Norfolk Boreas Offshore Wind Farm

Statement of Common Ground

Highways England

Applicant: Norfolk Boreas Limited
Document Reference: ExA.SoCG-8.D2.V1
Deadline 2

A47 - ACCESS AC160
SCALE - 1:500

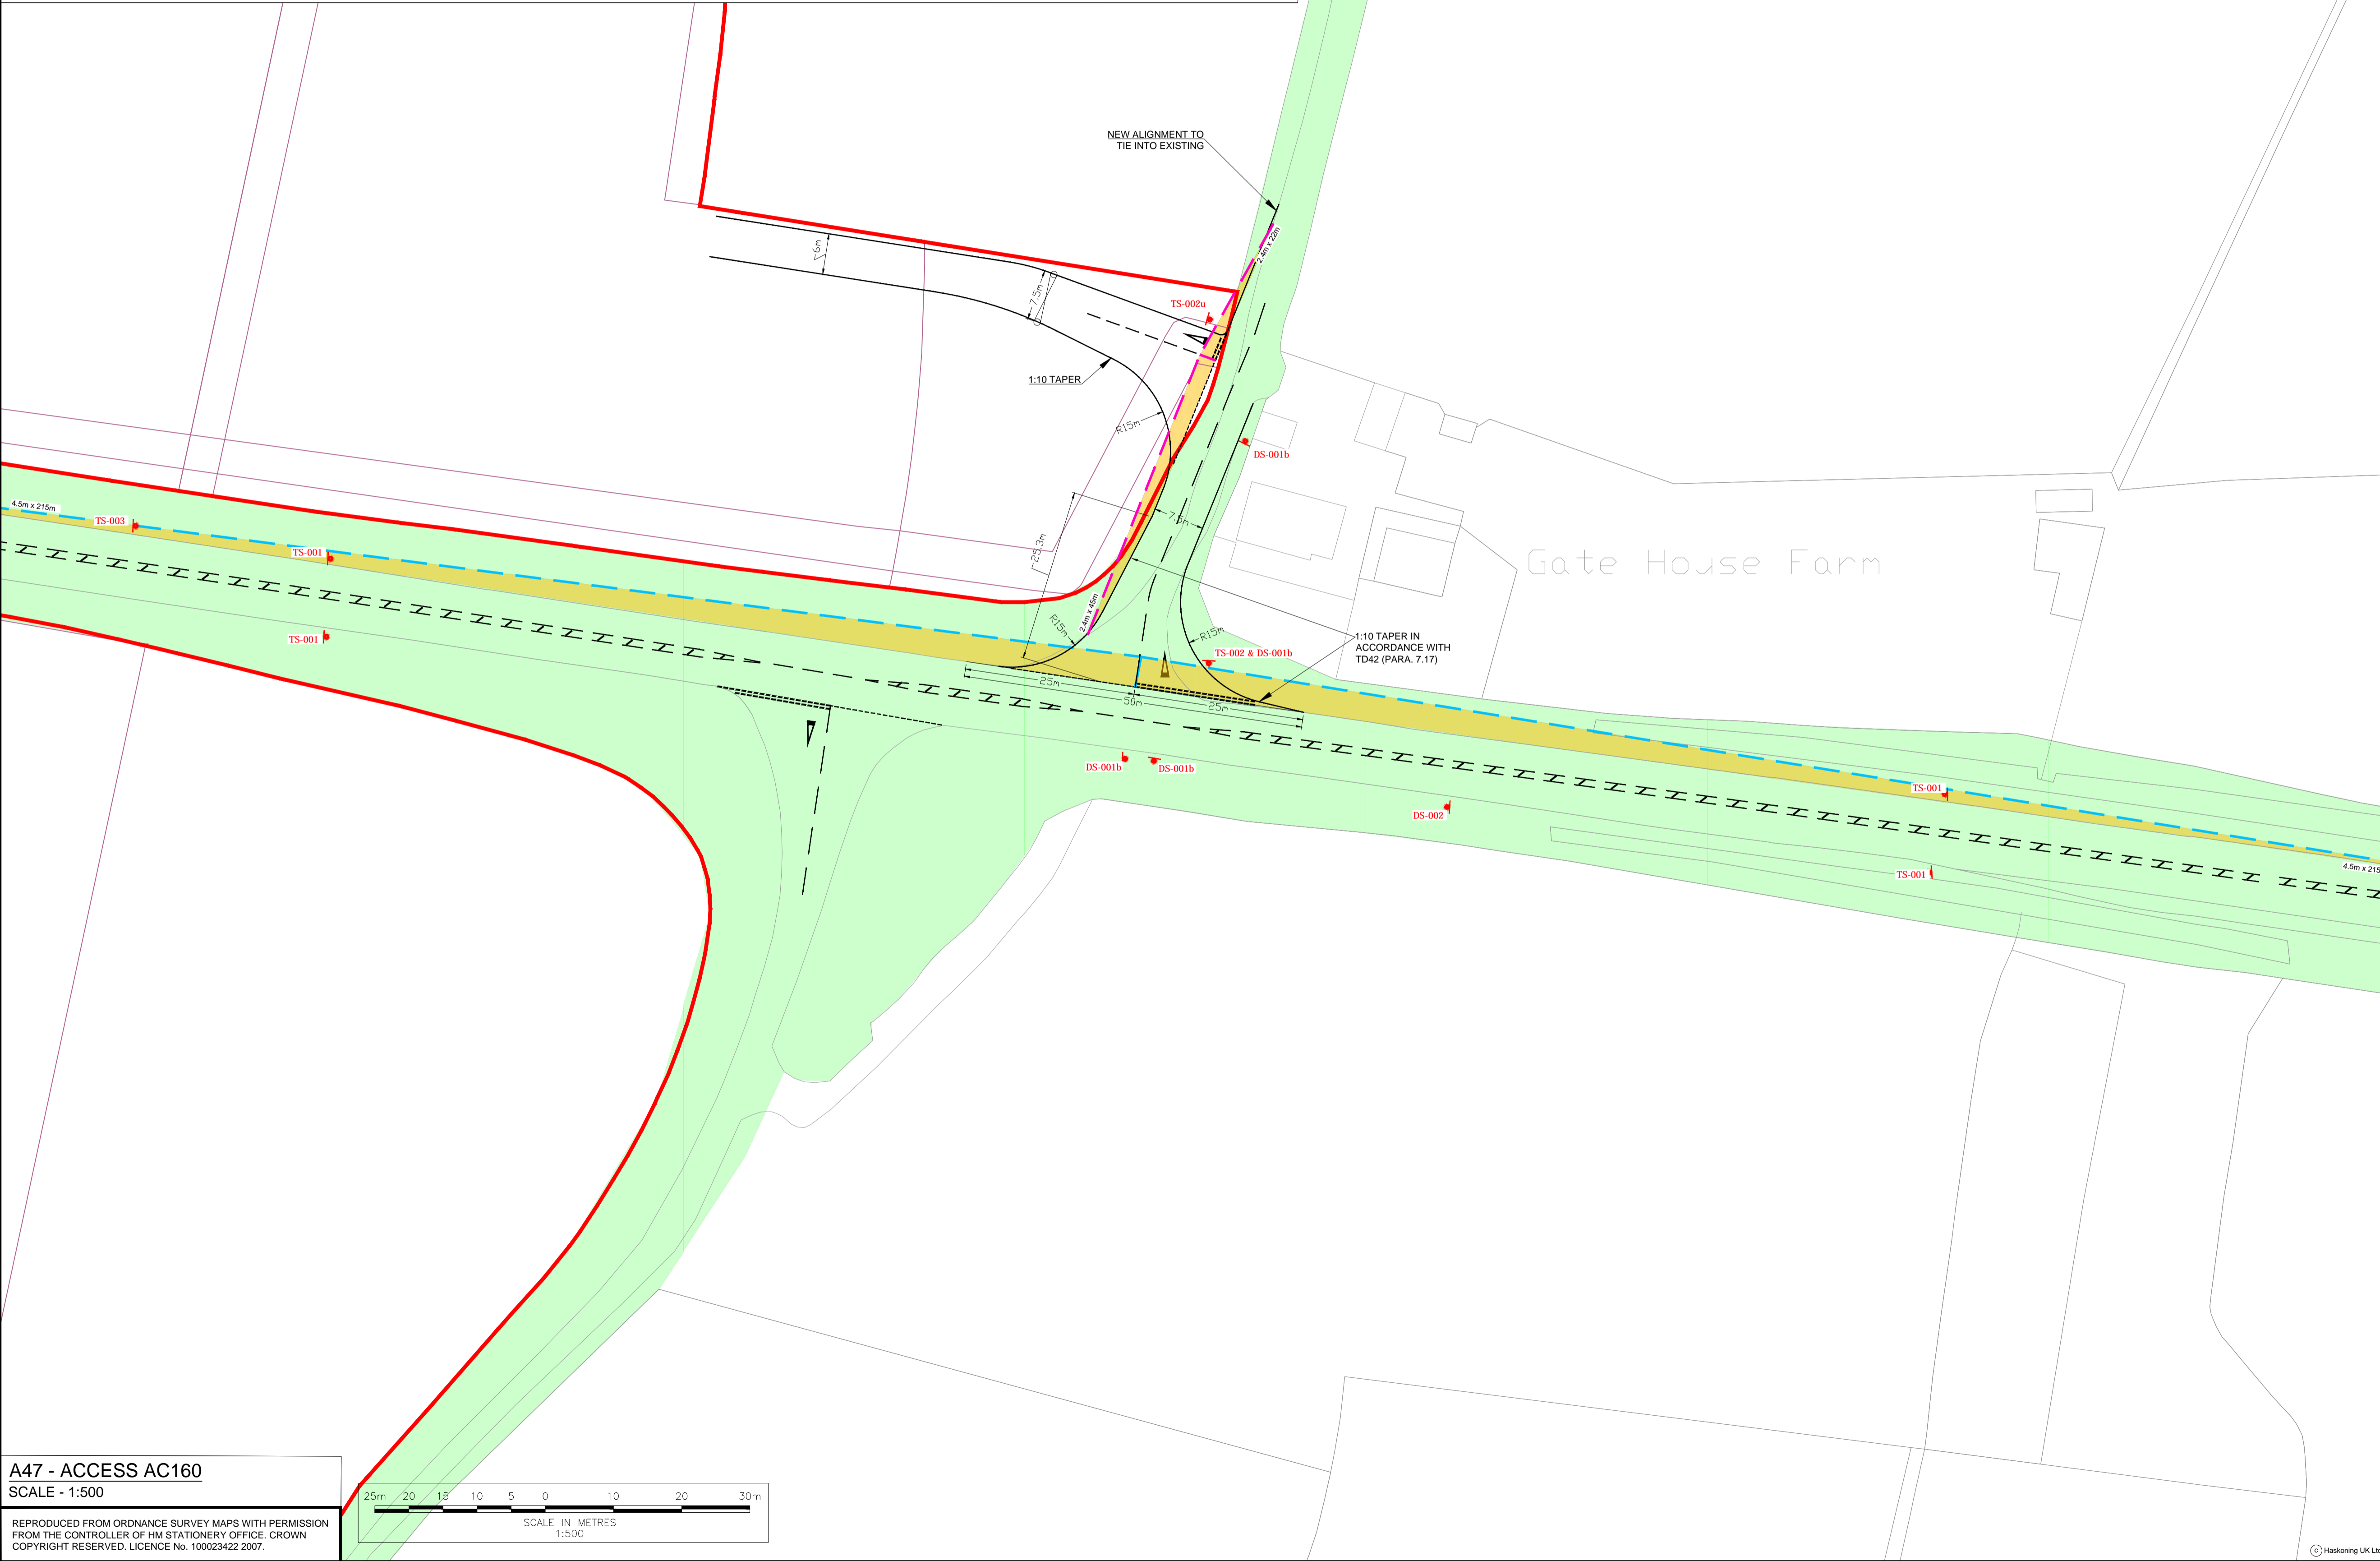
15. The layout of site access junction AC160 illustrated on Drawing PB4476-DR025 D0.1 appears to provide satisfactory geometry to accommodate heavy vehicles turning to and from the A47. There is no suggestion that the use of this junction by vehicles accessing the works would give rise to a queue of stationary traffic within Bushy Common Road waiting to enter the site, such as would risk generating a queue of traffic back to the A47, some 50m away.

19. The layout of the improved junction between the A47 and Bushy Common Road, illustrated on Drawing PB4476-DR025 D0.1, appears to provide in full for the requirements of DMRB Design Standard TD42 for this type of junction. In addition, the swept path plots shown on Drawings PB4476-DR026 and 027 show that it can accommodate heavy vehicles turning on and off the A47 without clipping kerb lines, and without encroaching on the wrong side of the A47 or the minor road.
